Please find enclosed the revised manuscript entitled “Mapping methane plumes at very high spatial resolution with the WorldView-3 satellite” that we submitted for publication in Atmospheric Measurement Techniques, Manuscript ID: amt-2021-238.

DETAILED EXPLANATION OF CHANGES INTRODUCED

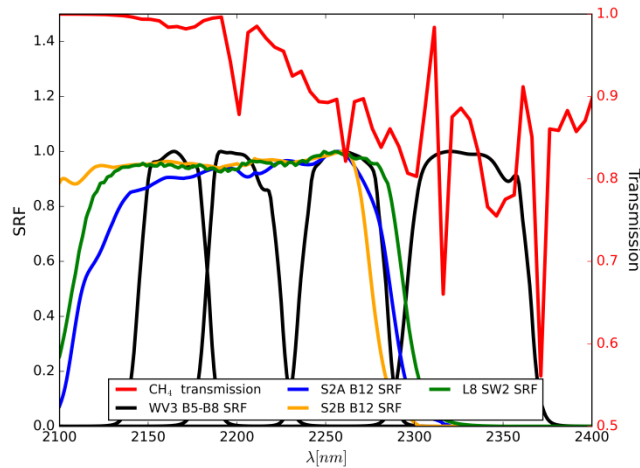
L101: band 5 still has CH₄ absorption ...

Thanks for pointing at this. We have updated the text accordingly for a better understanding in the 2.1 section when we describe the retrieval method by adding B5 in the explanation. The new paragraph looks like this:

“From the several options that have been considered (see Fig. 6), the selected method for the estimation of this “methane-free” band is based on a multiple linear regression (MLR) of B1-B6 with B7 as the target band (B7/B7_{MLR} method). Despite B8 being more sensitive to methane absorption, this band has shown lower spectral correlation with B1-B6 bands as compared to B7 (see results in subsection 3.1). Out of the six bands considered for the regression, three of them (B3, B5, and B6) are marginally sensitive to methane. In the case of B3, its weight on the regression is small and has negligible impact thus we do not include this band. However, in the case of B5 and B6, their spectral closeness to B7 improves the regression and outweighs the impact that the residual methane sensitivity of these bands produces on the retrieval. The effect of B5 and B6 on the retrieval performance was tested by producing a set of simulations that do not incorporate the methane plume transmittance on these two bands. The performance of these fit-for-purpose products was compared to the full end-to-end simulated products. We find that including these spectral bands with partial methane sensitivity in the MLR reduces the integrated methane enhancement (IME; total excess methane mass; Frankenberg et al., 2016) of retrieved plumes roughly 7%.

Here we attach a more visual explanation of this residual absorption in B5 and B6.

As we pointed in the manuscript (particularly in section 3.1), we estimated a loss of around 7% in the IME. This test simulated the retrieval with an added methane plume on B7 and no effect on the rest of the bands (including B5 and B6). Further iterations of the methodology might seek a correction procedure for this effect.
